CALIFORNIA REGIONAL WATER QUALITY CONTROL BOARD
SAN FRANCISCO BAY REGION
1111 JACKSON STREET, ROOM 6040
OAKLAND 94607

October 3, 1989

Subject: Exxon Station # 7-3399, 2991 Hopyard Road, Pleasanton,
California

Sketch Map of Suggested Monitoring Well Locations

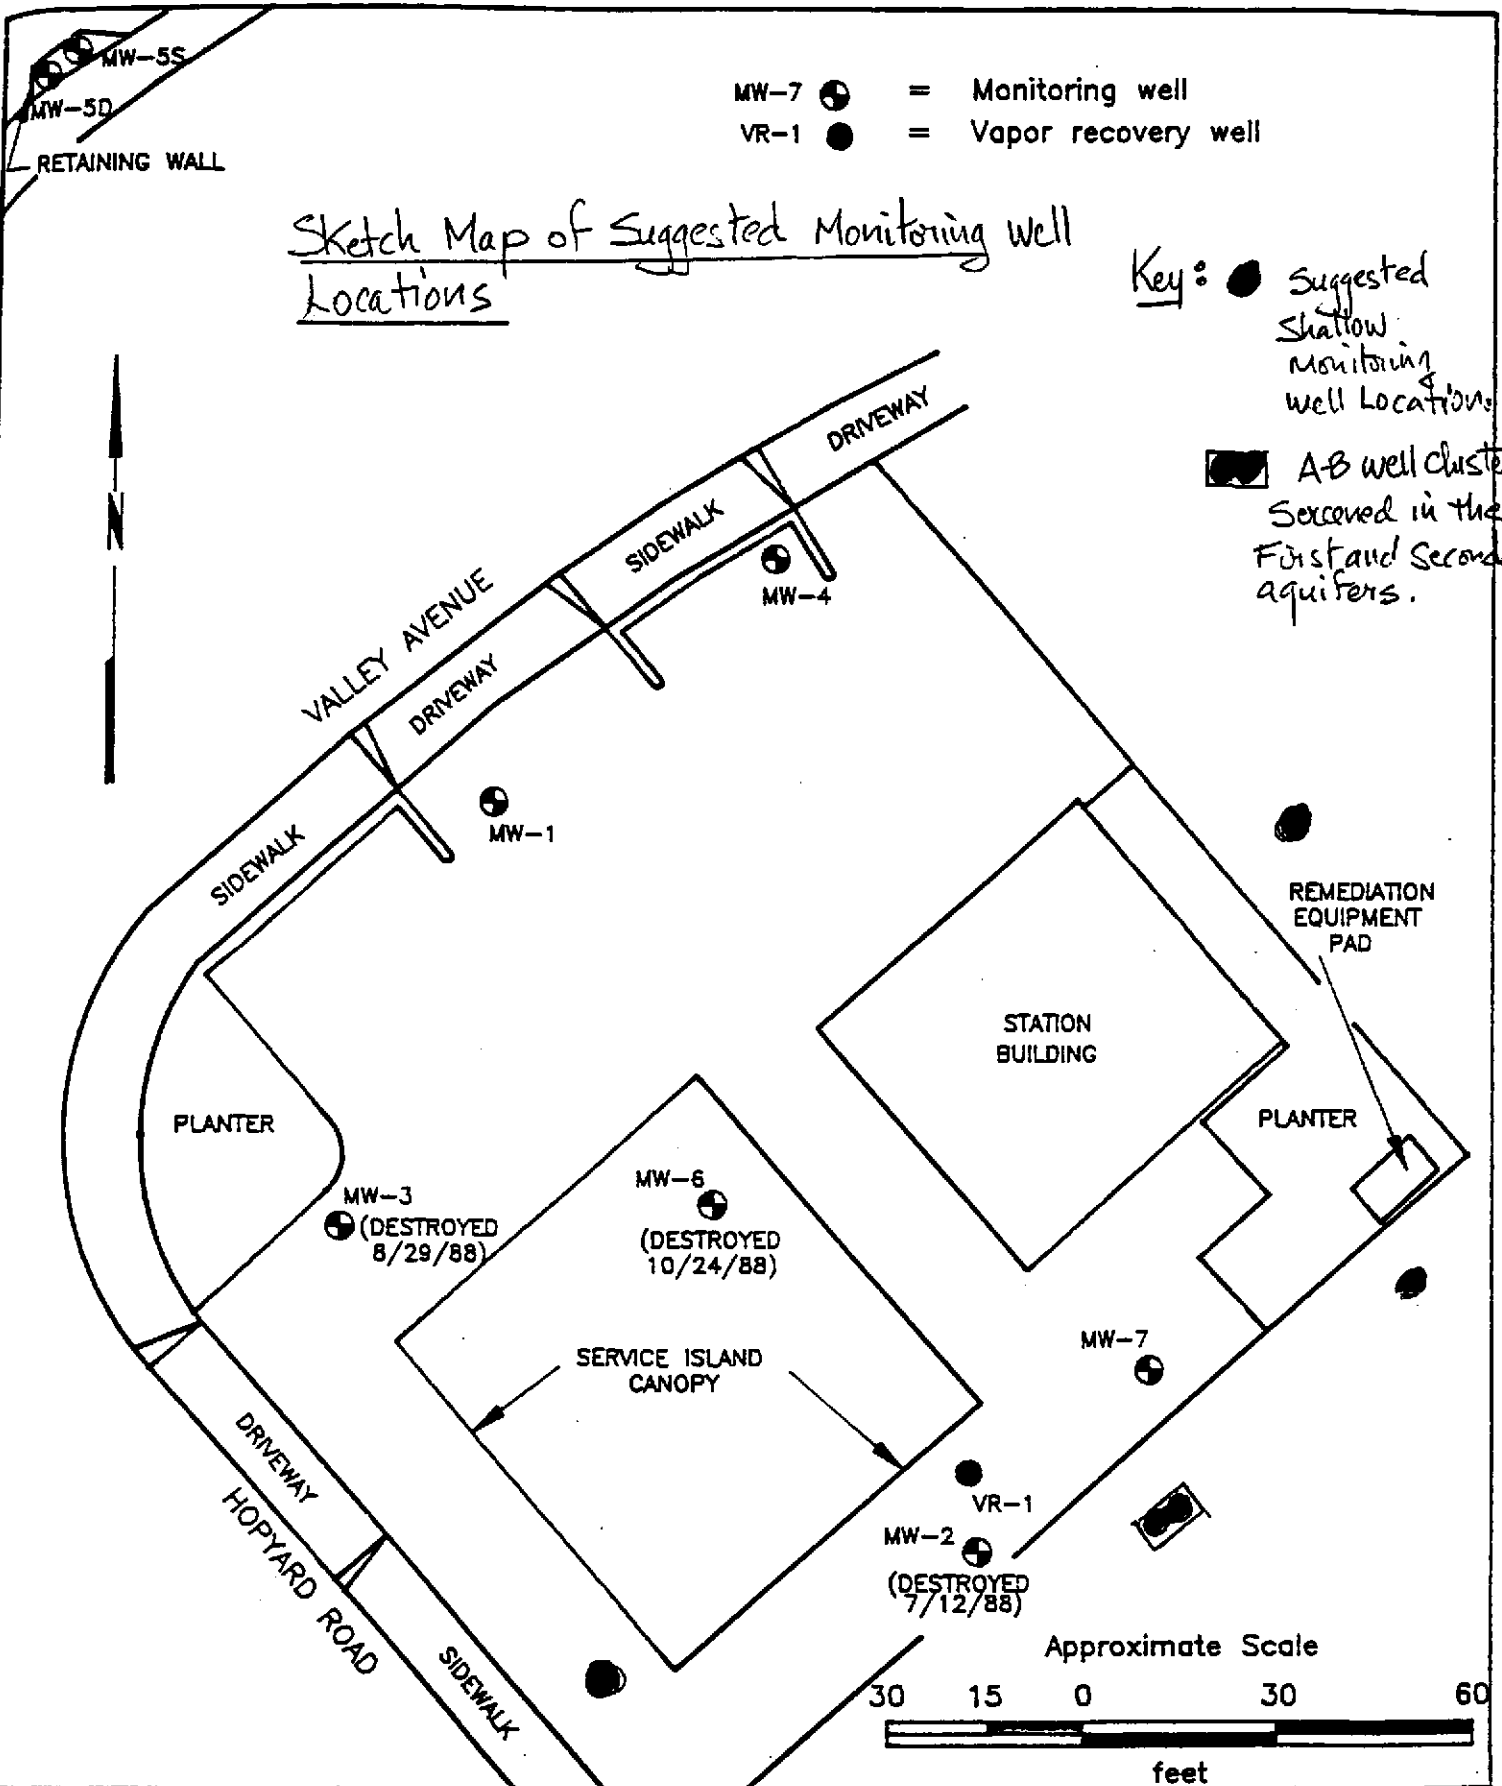
Following our telephone conversation on September 14 concerning proposed well locations, representatives of the City of Pleasanton, Zone 7, and the Board met to discuss the status of soil and groundwater remediation at the referenced station. During the meeting on September 20th, I reviewed the proposed shallow well locations. While replacement of mw-6 with an equivalent well (upgradient from the spill) was deemed reasonable, concern was expressed that a single shallow well in the prevailing downgradient direction would not adequately define the vertical and lateral extent of soil and groundwater pollution to the Southeast. Consequently, we believe the following is appropriate:

1. Installation of an A-B well cluster screened in the first and second water-bearing zones to be located directly to the Southeast of mw-7 and mw-2 (where we had previously sited the single downgradient well).
2. Three additional shallow wells forming a 180 degree ring in the prevailing downgradient direction around the spill site (see attached sketch map), to define the extent of soil and groundwater pollution.
3. If significant contamination is found at any of these wells, additional wells will be required to be in compliance with the November 3 deadline for complete site characterization required by Cleanup and Abatement Order 89-132.

As I indicated to you earlier, it is the responsibility of Exxon and its' consultant(s) to determine actual well locations and obtain any appropriate drilling permits. Accordingly, the sketch map is provided to you as a suggestion only.
